Flying Horse North PUD/SP Amendment (Filing 9) Preliminary Drainage Report Amendment

June 2026

HR Green Development, LLC
1975 Research Parkway, Ste. 160
Colorado Springs, CO 80920
Contact: Richie Lyon, PE
Richie.Lyon@hrgreen.com
719-318-0871

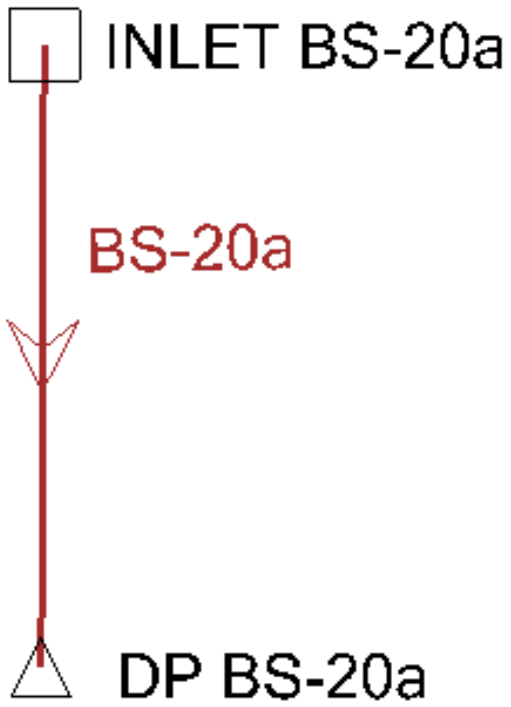
Please review and revise the calculations as necessary to reflect the correct flow rates.

DETENTION BASIN OUTLET STRUCTURE DESIGN

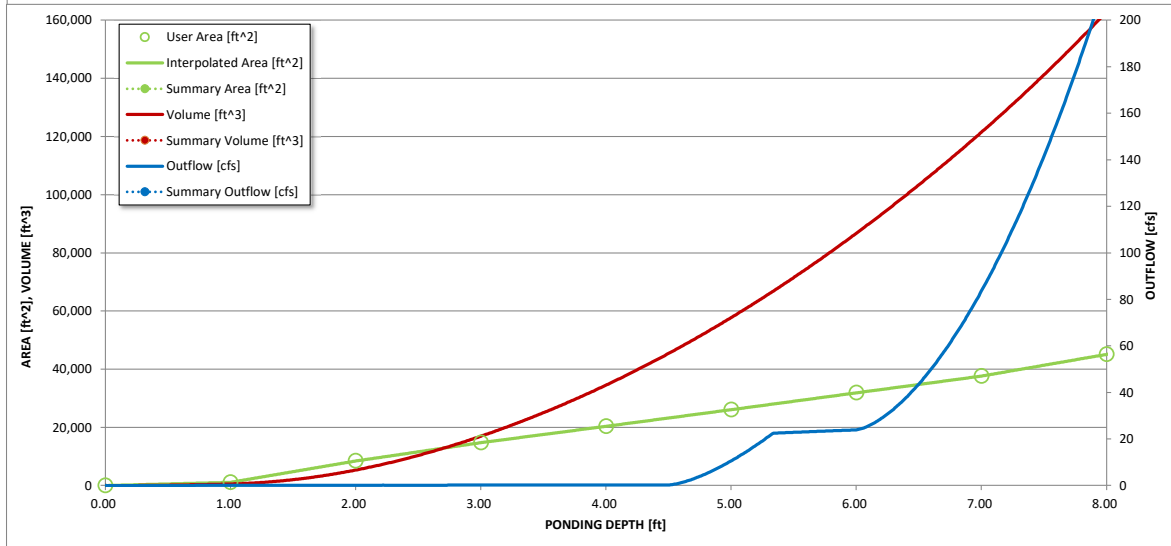
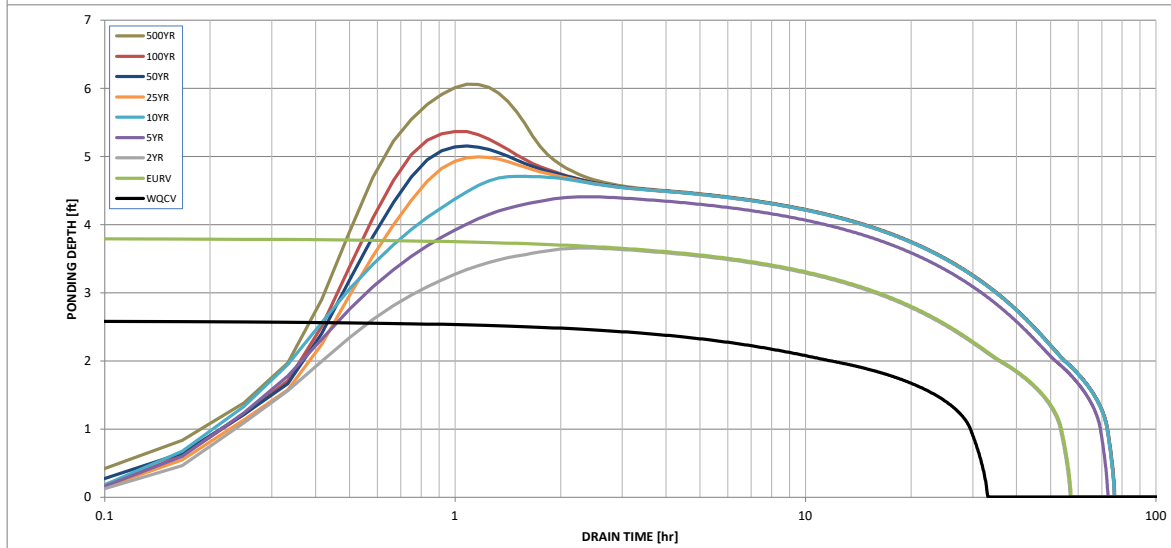
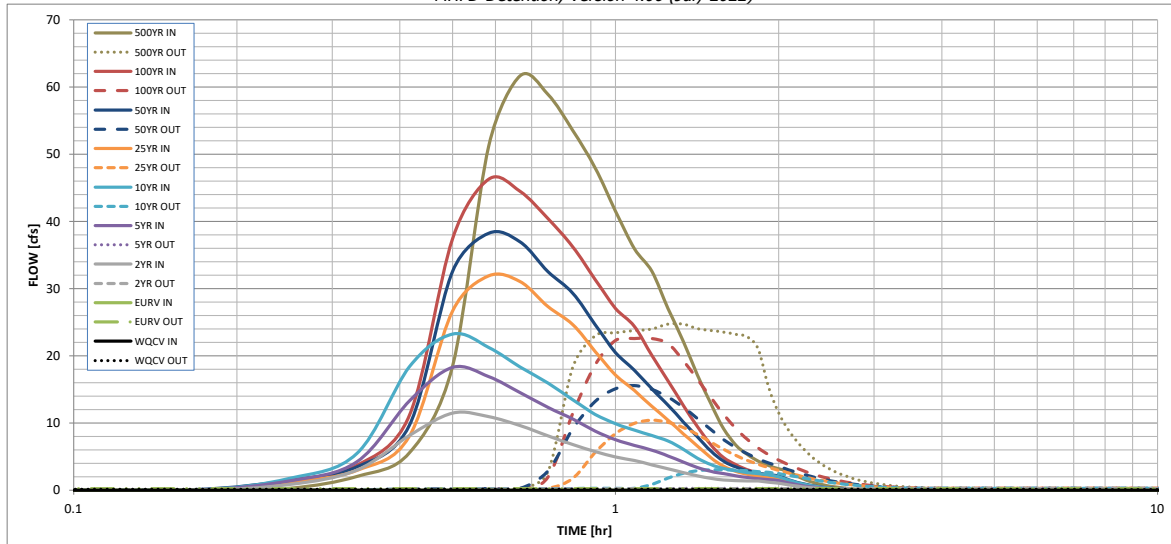
REQUIRES ORIFICE PLATE REPLACEMENT DUE TO ANALYSIS OF AS-BUILT BASINS IN THIS REPORT. SEE PROPOSED POND A CONDITION.

DETENTION BASIN OUTLET STRUCTURE DESIGN

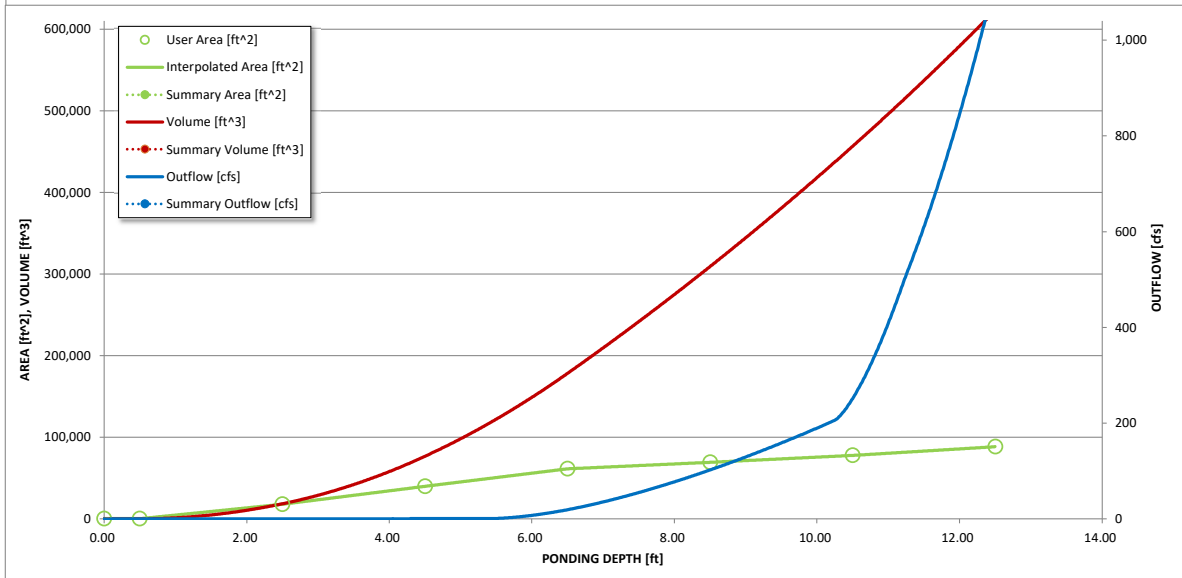
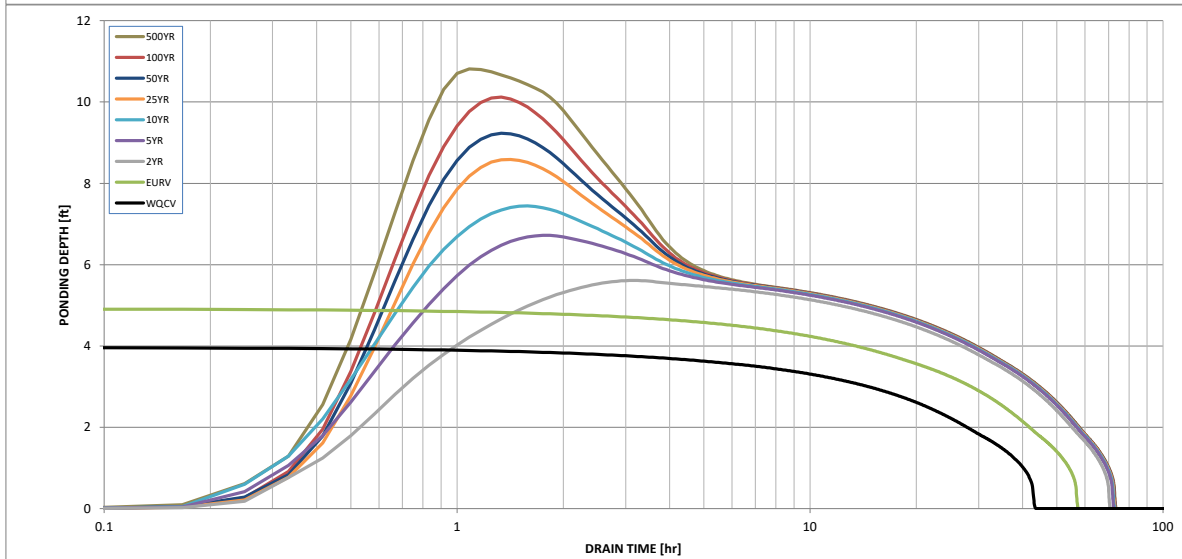
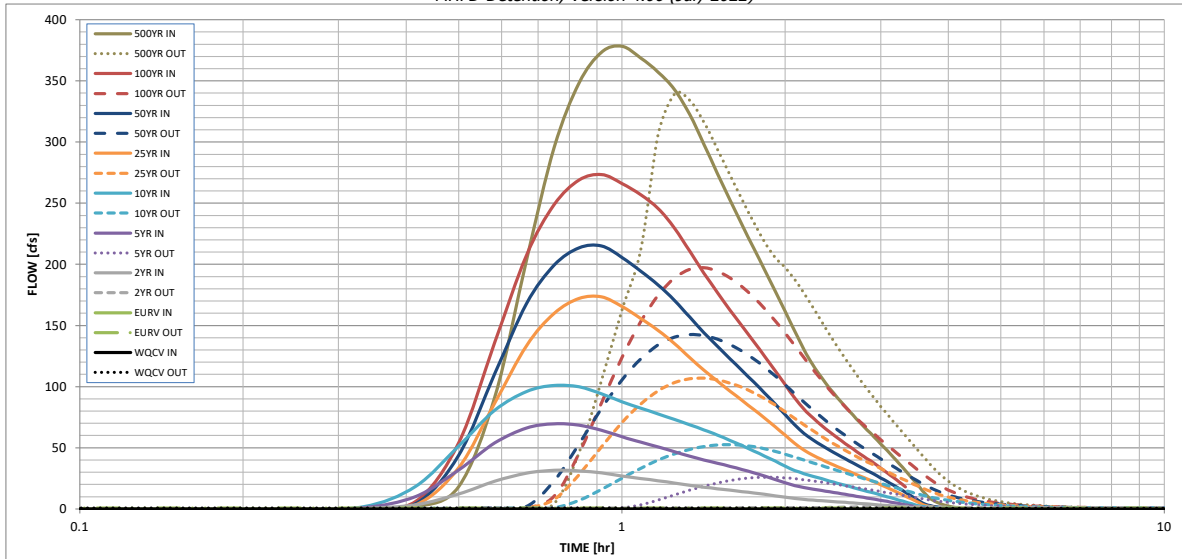
Replace orifice plate.
